Deck Repair

CODE COMPLIANCE: 2021 INTERNATIONAL EXIST BLDG CODE 2923 S. MERIDIAN ST (BLDG I) SITE ADDRESS: 0419032096 NUMBER OF DECKS: 6 DECKS

Meridian

(Construction Plans, Sheet A1.1)

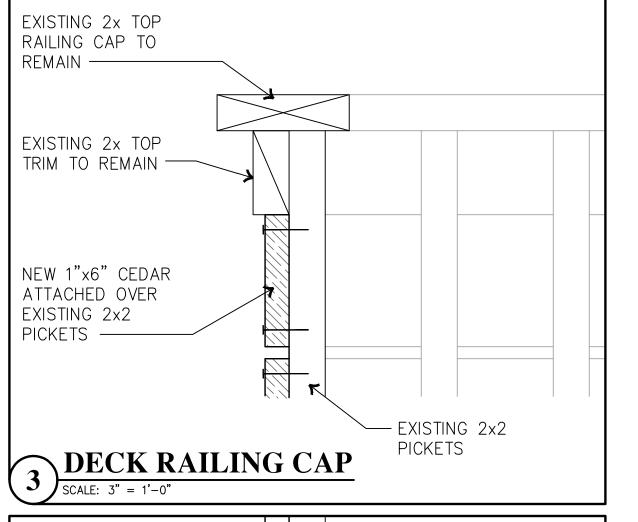
Determine the minimum required specifications for deck beams, posts, post bases, post caps and footings if replacements are necessary. Given the work already completed and the stop-work order in place, establish a clear benchmark to assess the completed work and provide clarity for future construction and inspection, minimizing any potential ambiguities.

(Construction Plans, Sheet A1.1)

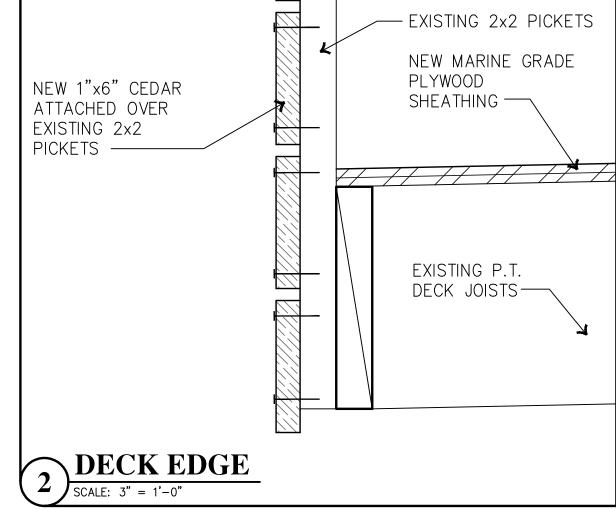
Deck joists appear to be sloped to drain off of the cantilevered side of each deck based upon details 1 and 2. Detail 2 shows the installation of the 1x6 cedar board over the existing 2x2 balusters. detail or notate how the 1x6 cedar will be installed to prevent drainage and water accumulation on the deck surface.

(Construction Plans, Sheet A1.1)

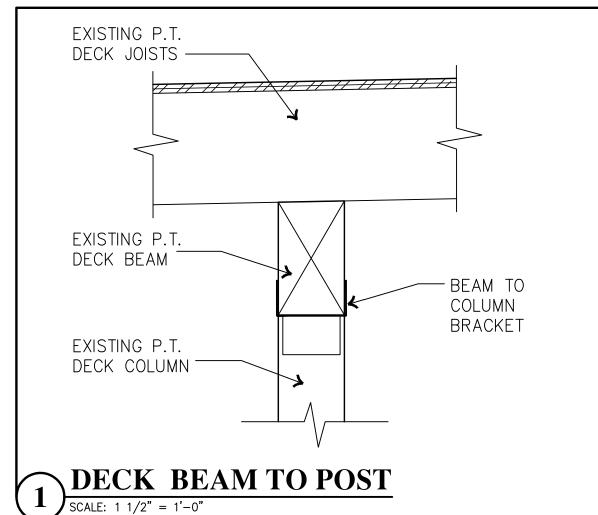
Add a notation on either Sheet A1.0 or A1.1 that contractor shall verify the integrity of balusters prior to the installation of the 1x6 cedar. Establish the parameters of the balusters replacement to include type, grade and nailing pattern.
